# 1960 Corvette: Service Bulletin: Accelerator Pedal Falls Off Retaining Studs

**Subject:** Accelerator Pedal Falls Off Retaining Studs

**Model and Year:** 1960 Corvette Models

**Source:** General Motors of Canada - Service Bulletin

Fig. 31.

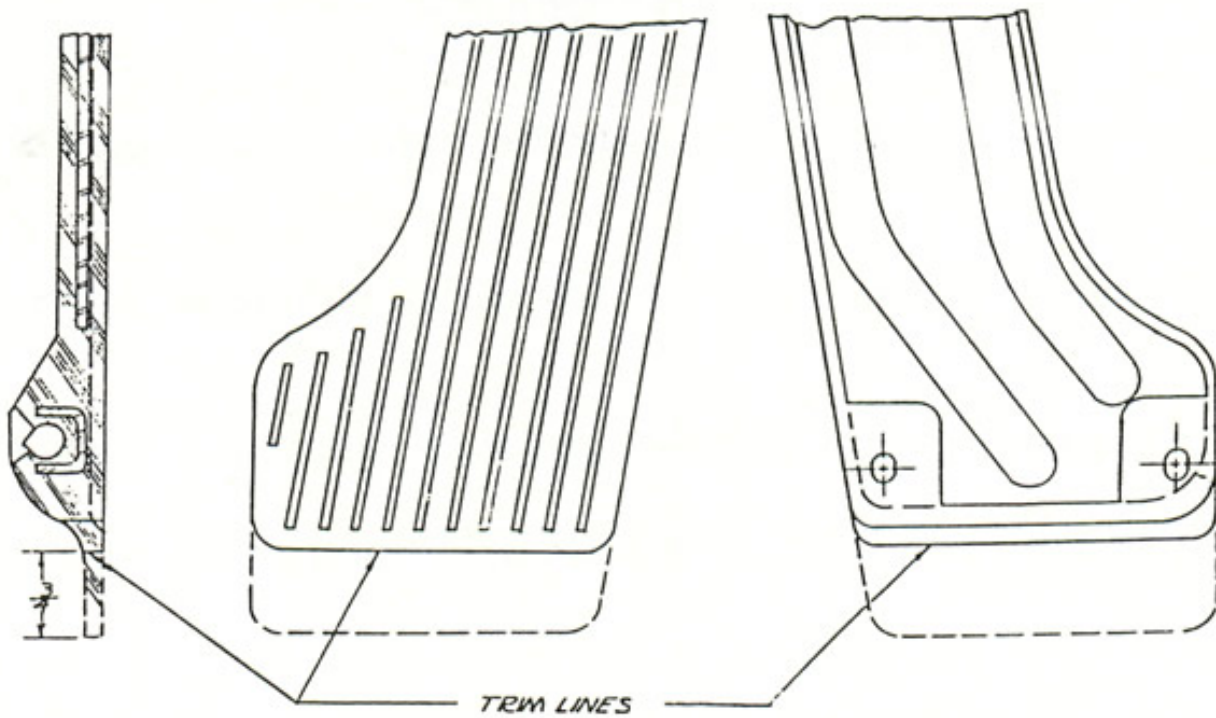
There has been a few complaints that the 1960 Corvette accelerator pedal snaps off of the two retaining studs at the heel end of the pedal, due to an interference condition between the floor mat material and the heel flap of the pedal.

REWORK INSTRUCTION DRAWING TO COVER THE MODIFICATION OF  
THE 1960 CORVETTE ACCELERATOR PEDAL # 3771749

As a Production correction, the assembly plant will revert to the 1959 design pedal, part #3760271, which does not incorporate the heel flap.
